#### **Global technical regulation No. 9 (Pedestrian safety) – Phase 2 of the global technical regulation**

### **Proposal for Amendment 2 (DRAFT-ver.121206)**

#### **Submitted by the chairperson of informal working group on Global technical regulation No. 9 (Pedestrian safety)-Phase 2\***

Figure 28 Flexible lower legform impactor test set-up for dynamic lower legform impactor certification test, inverse type (see paragraph 8.1.3.4.)

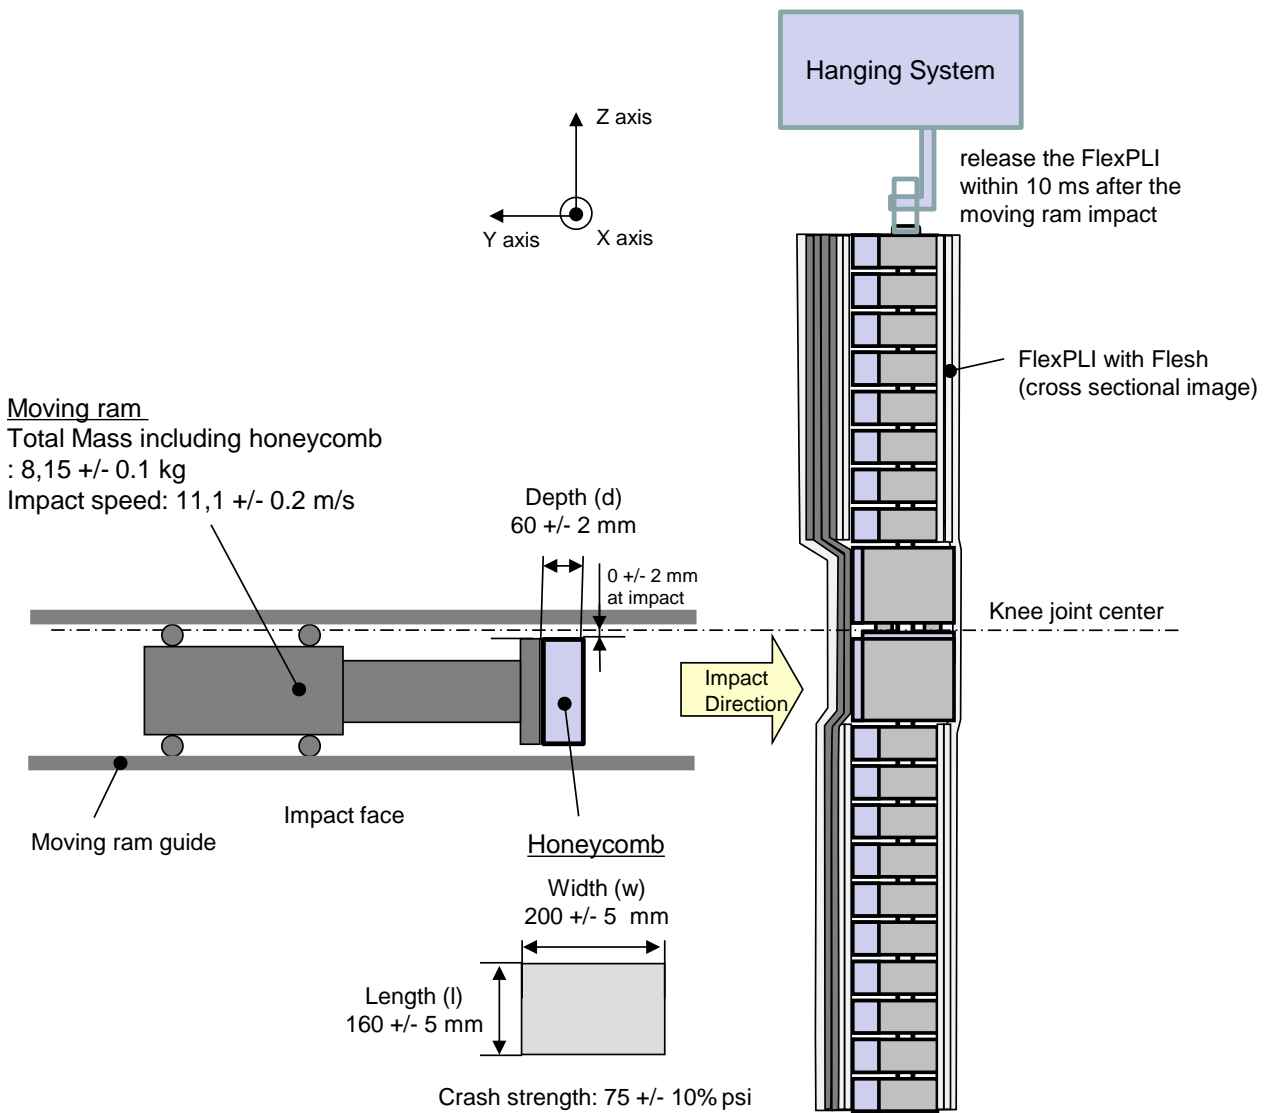
8.1.3.4.1. The fully assembled lower legform impactor (with flesh and skin) shall be stationary suspended vertically from a test rig as shown in Figure 28. It is then impacted by the upper edge of a linearly guided Al honeycomb impactor, covered by a thin (less than 1 mm thickness) paper cloth, at an impact speed of  $11,1 \pm 0,2$  m/s. The legform is to be released from the test rig within 10 ms after the time of first contact to ensure a free flight condition.
